DeKalb County Historic Preservation Commission

Staff Report

F. 1071 Oxford Road, Dan Hanlon. Construct a second-story addition and demolish a porte cochere and enclosed porch on a historic house. **1247715.**

Built in 1927 (18 002 04 016)

FRONT ELEVATION
SCALE: 1/4" = 1'-0"

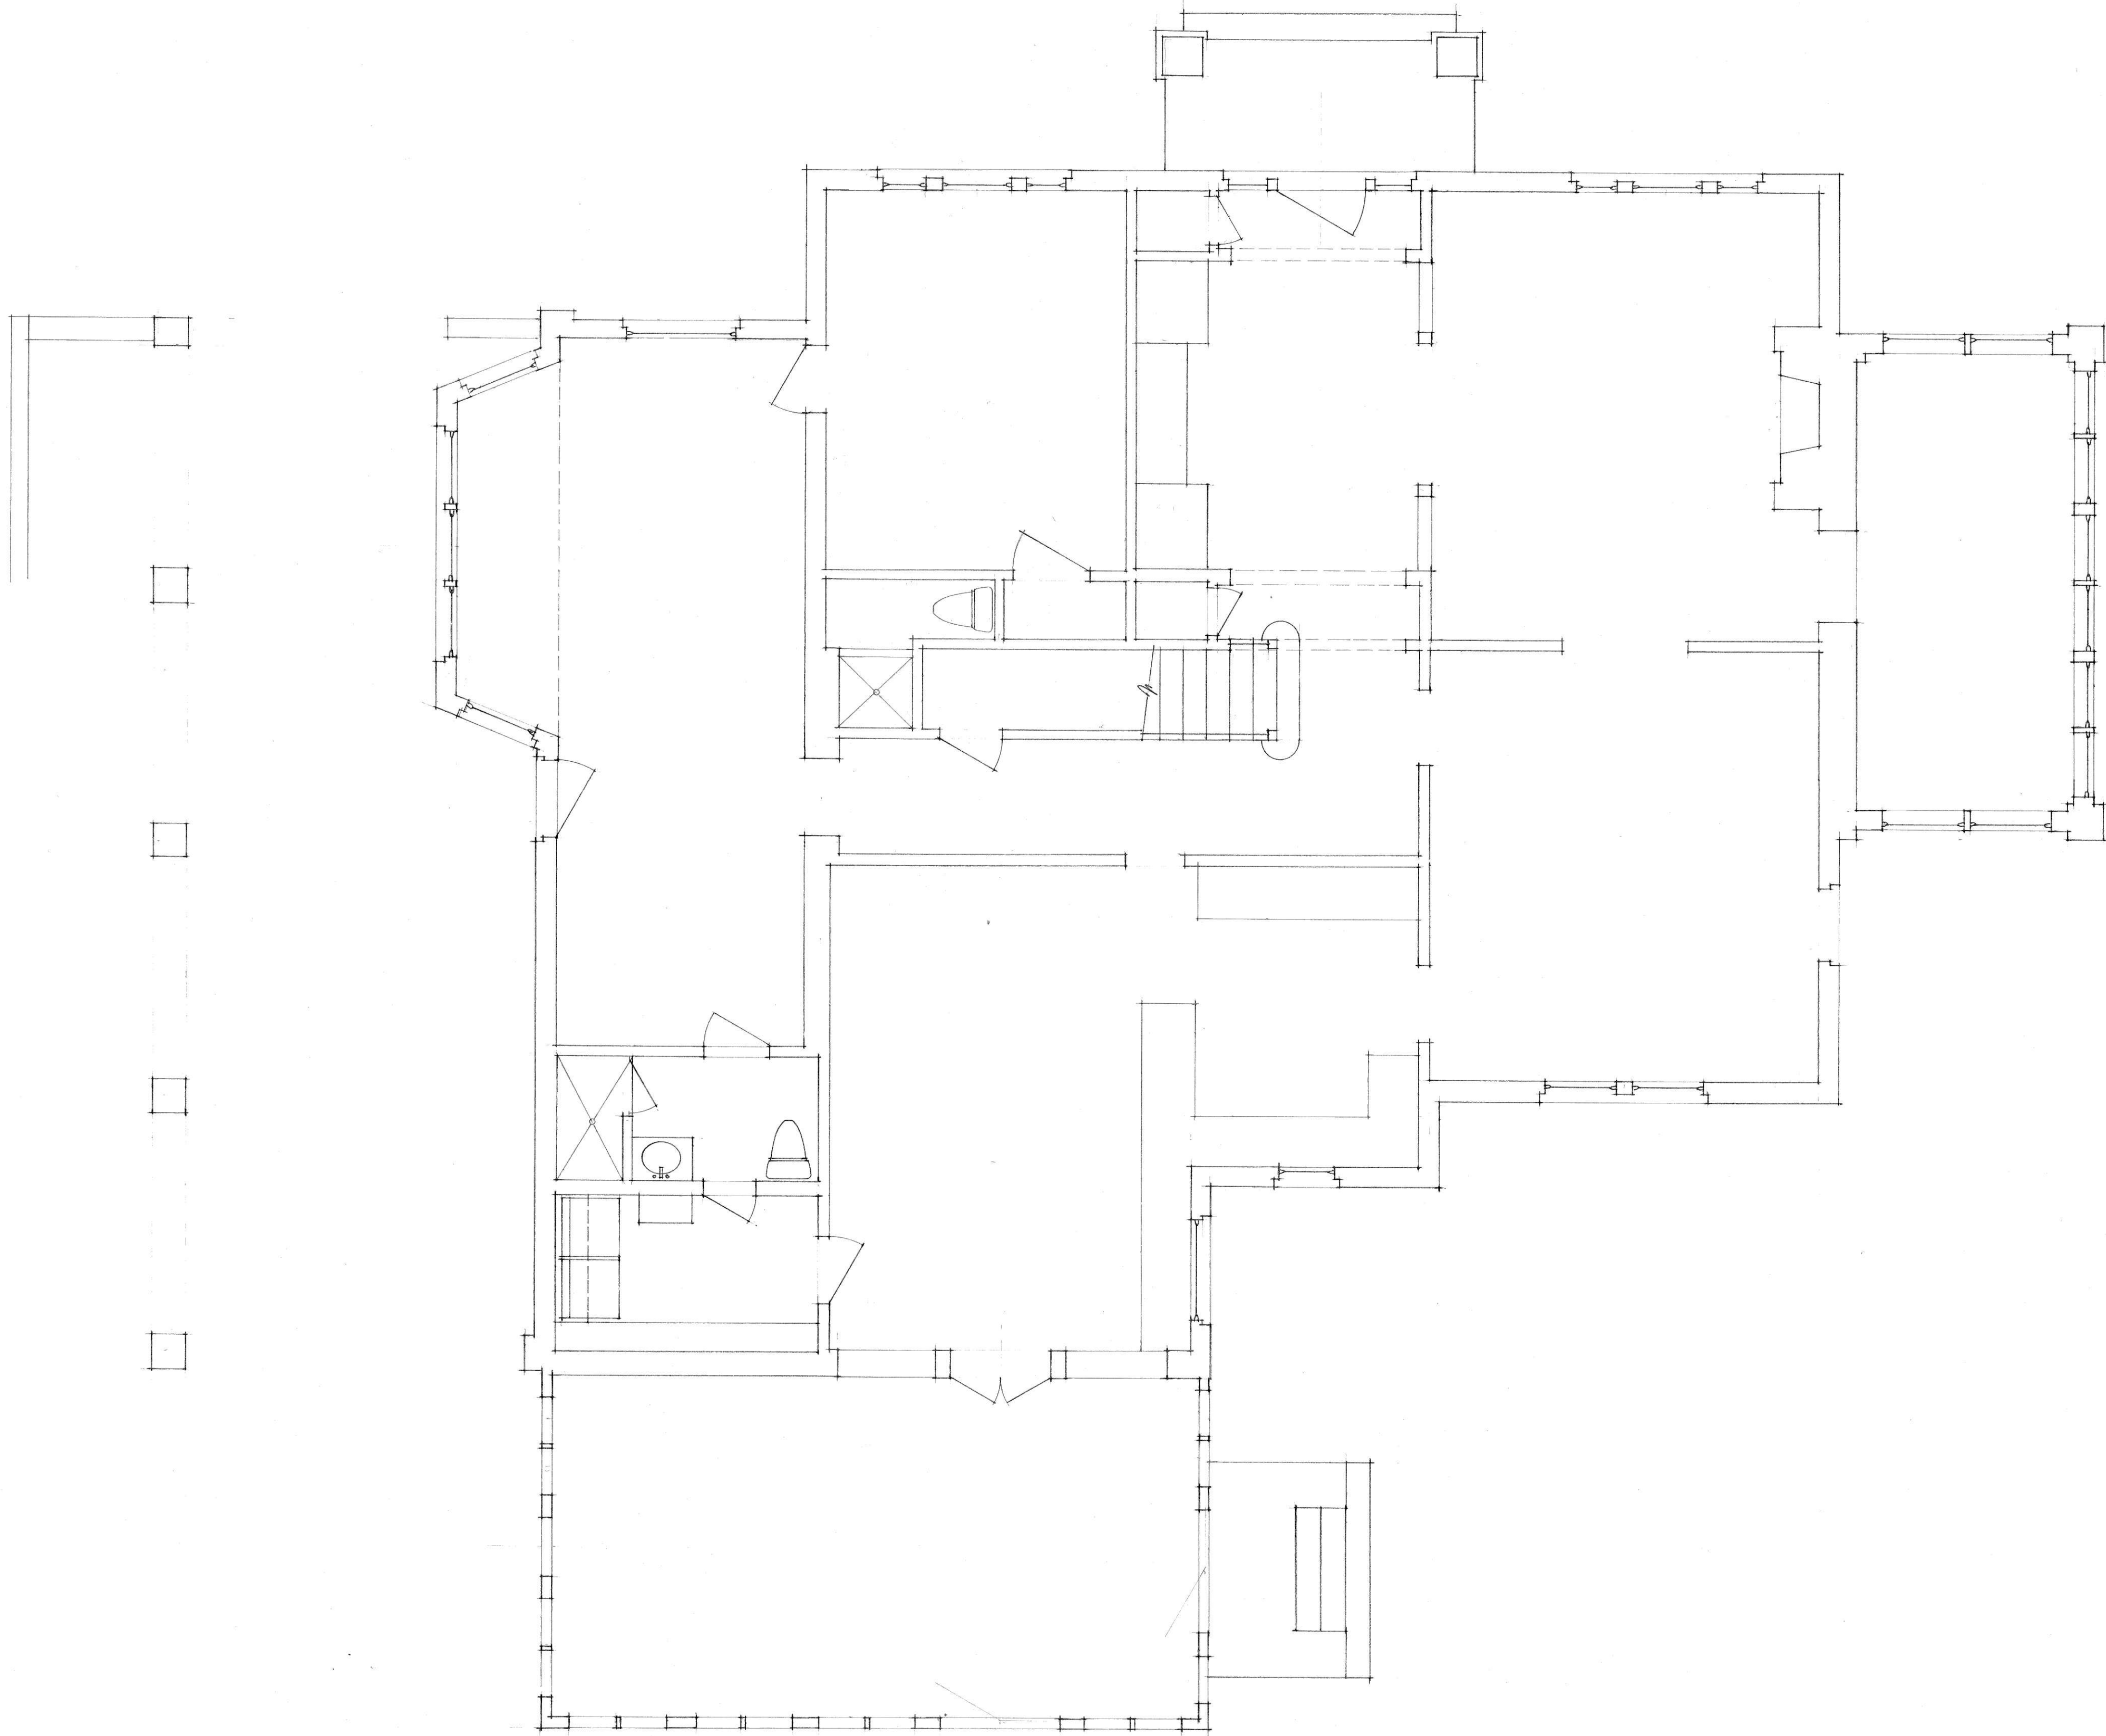
As we understand it, under the rules of the historic district and based on our own experiences, the front of the residence visible from the street, is not supposed to be materially changed. As longtime residents of the neighborhood, we also know the three (3) examples of similar double garages that Mr Hanlon has included in the application were added to their structures PRIOR to the institution of the historic district rules. Those front-facing, attached, two vehicle garages are not typical of the vast majority of the houses from the historic period. Furthermore, the absence of those front-facing, dominant garages is something that distinguishes the district

from other residential areas. This change would make 1071 Oxford look like a 1990's house with a big attached garage visible from the front. Again, most of the houses in the neighborhood don't have attached double garages. In addition, removing the porte cochere, materially changes how 1071 will look from the street, and eliminates a feature that is representative (and distinguishes) the district.

We would also observe that the scale and size of the reconstruction/addition observable and prominent from the street will be significantly increased, thereby potentially affecting the district's characteristics.
